**CITY OF BELMONT
PLEASANTS COUNTY, WEST VIRGINIA**

CONTRACT #2 – WATER TREATMENT PLANT UPGRADES

ADDENDUM #2

THRASHER PROJECT #T10-11028

EXISTING FILTER BUILDING - DEMOLITION PLAN
 SCALE 1/4" = 1'-0"

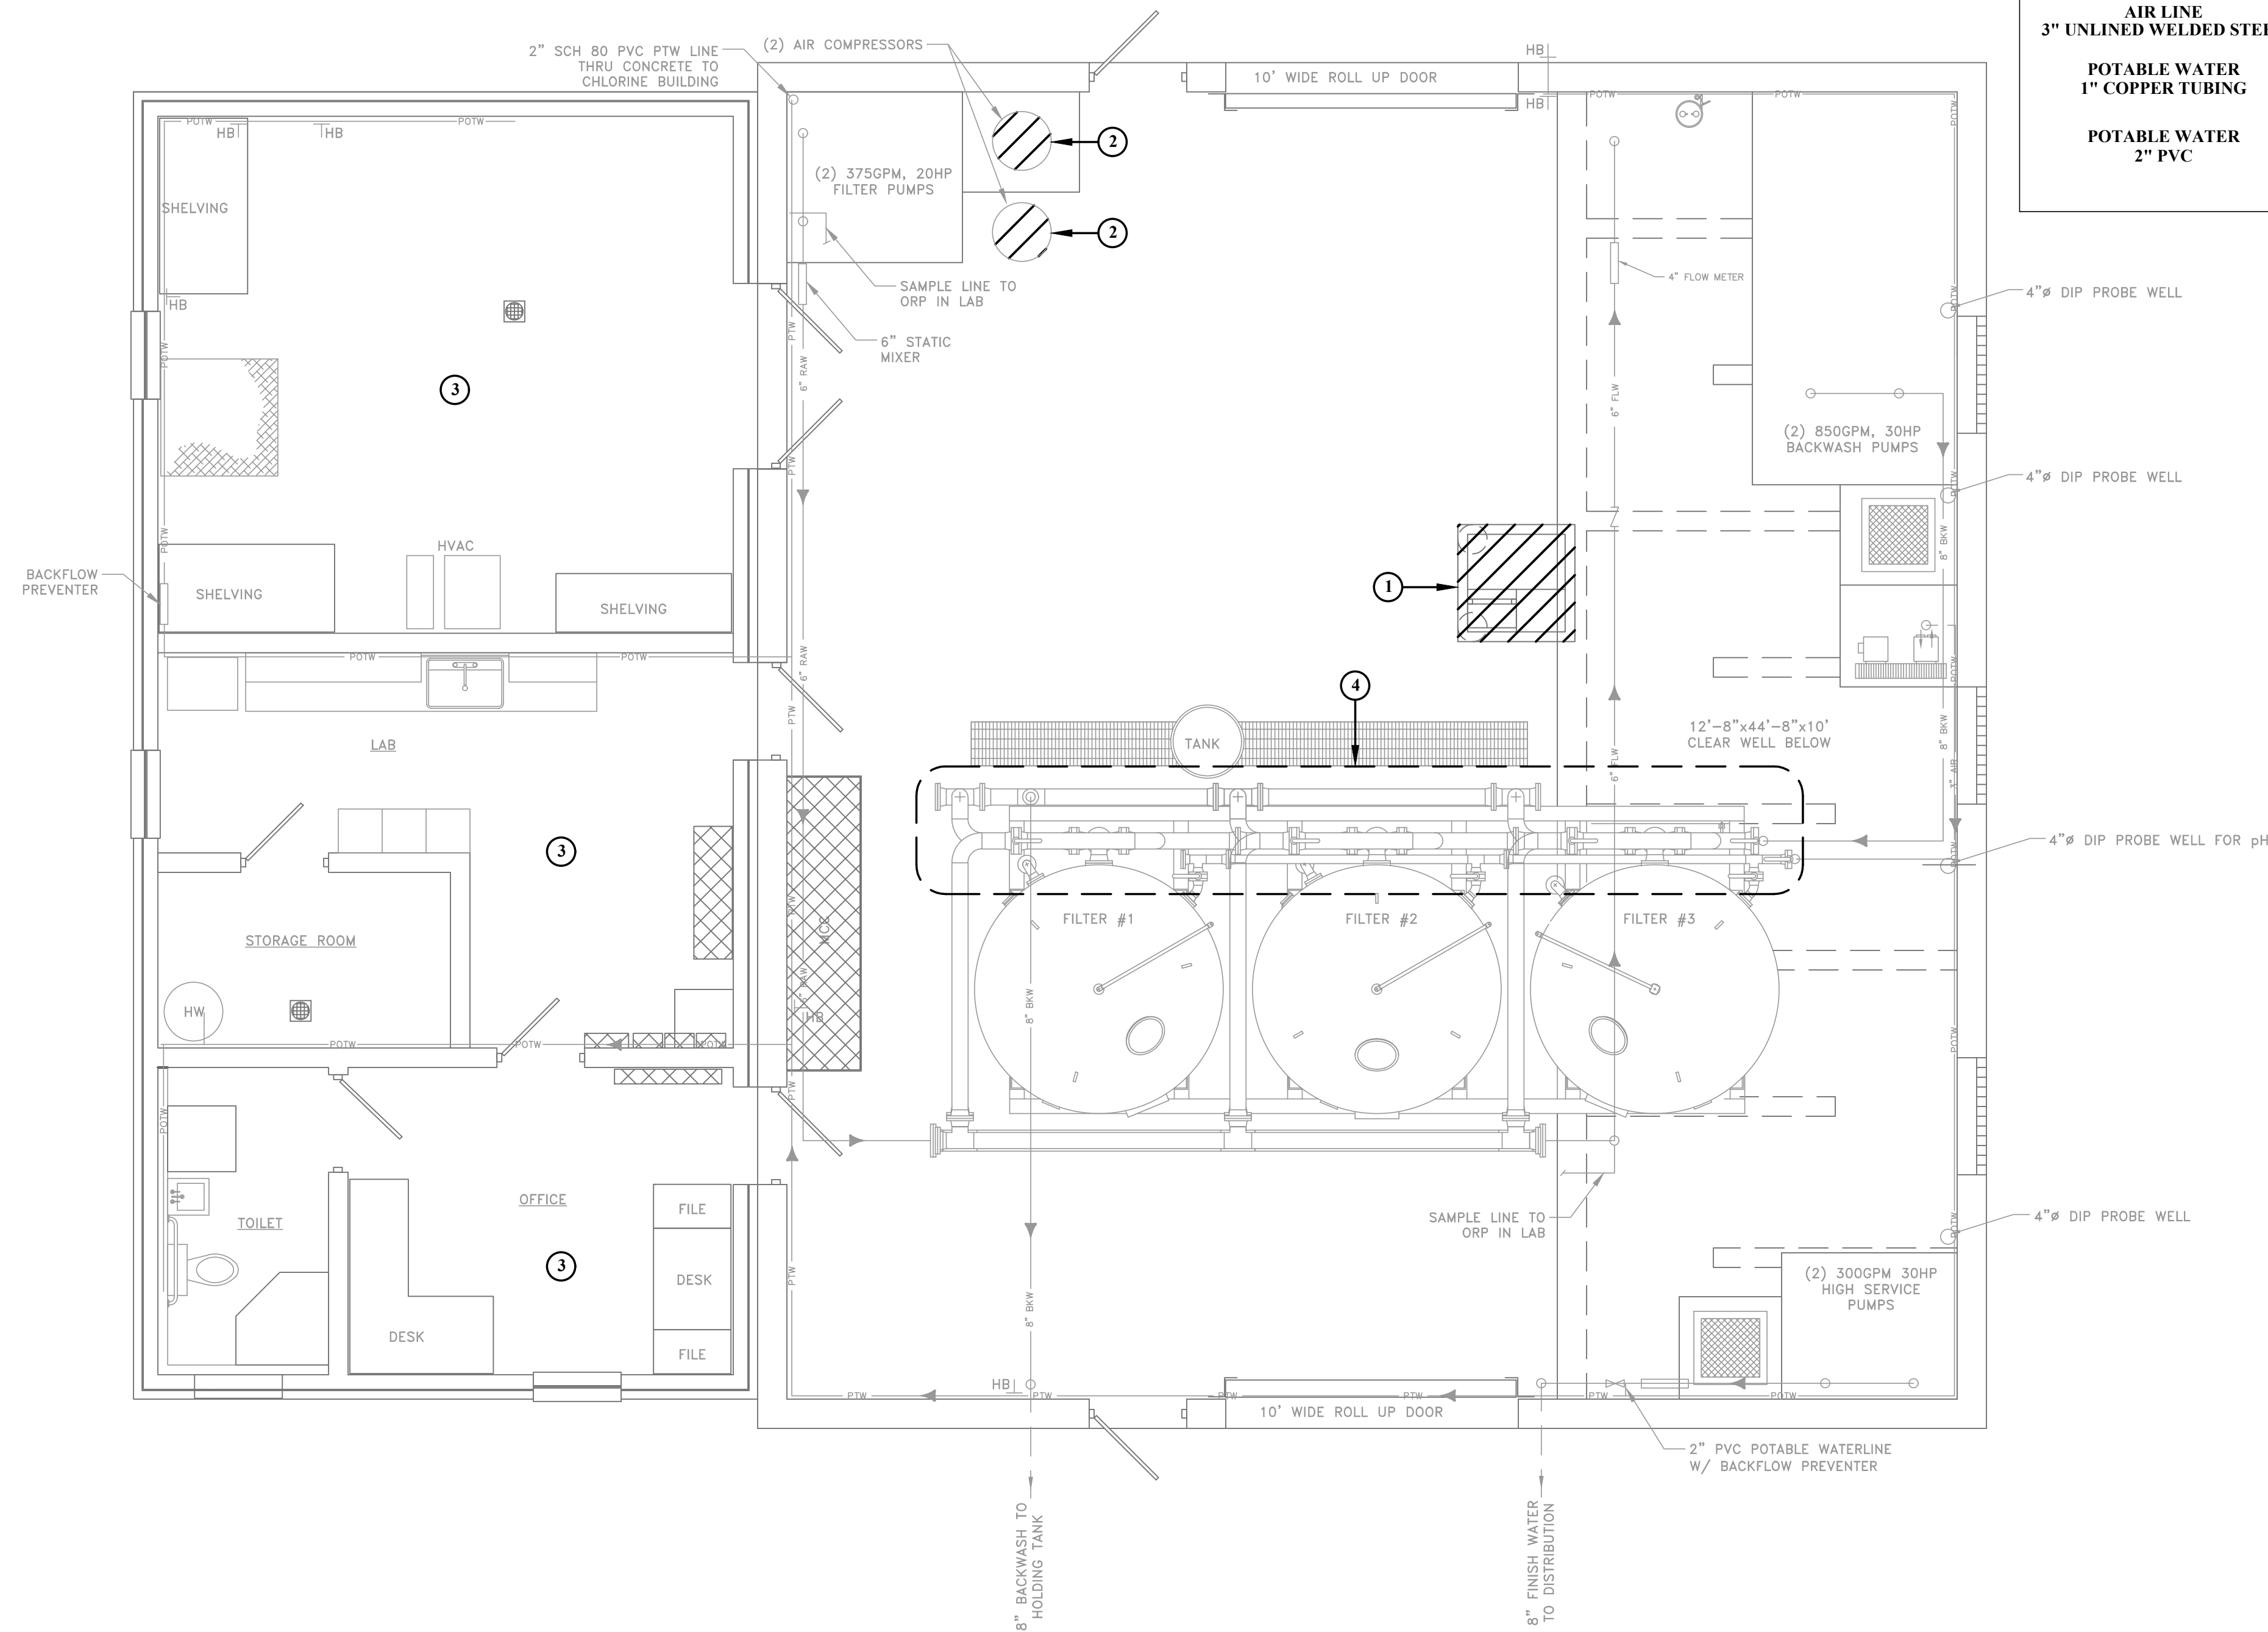
There is an area on the Existing Filter Building – Demolition Plan (Sheet 1) that shows as coded note #4. There is not a description in the Demolition Notes on that sheet for note #4. Will you provide that description?

NO.	BY	DATE	DESCRIPTION
1	ISF	7/30/24	ADDENDUM #2 - ADDED DEMOLITION NOTE 4

Drawing Sheet 1 has been revised and is enclosed with this Addendum #1.
